Product / Process Change Notification (PCN)

PCN #: PCN_conPSHD_20240315

Affected Series: WR-PSHD ; 60800213421

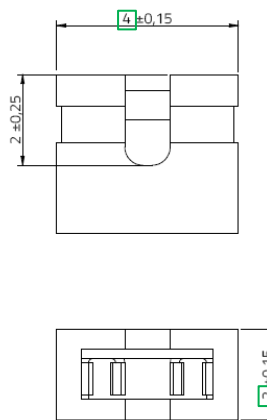
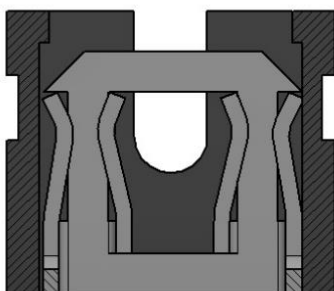
Contacts' shape is evolving.

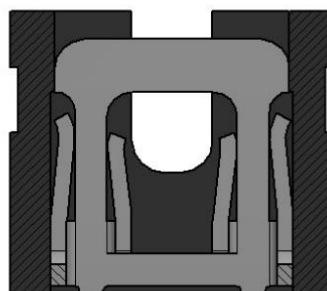
Specifications changes:

BEFORE	AFTER
Rated Current	1 A max	3 A max
Withstanding Voltage	500 V(AC) (1 min)	650 V(AC) (1 min)
Insulation resistance	500 MΩ	1000 MΩ
Operating temperature (°C)	-40 °C up to + 105 °C	-25 °C up to 105 °C
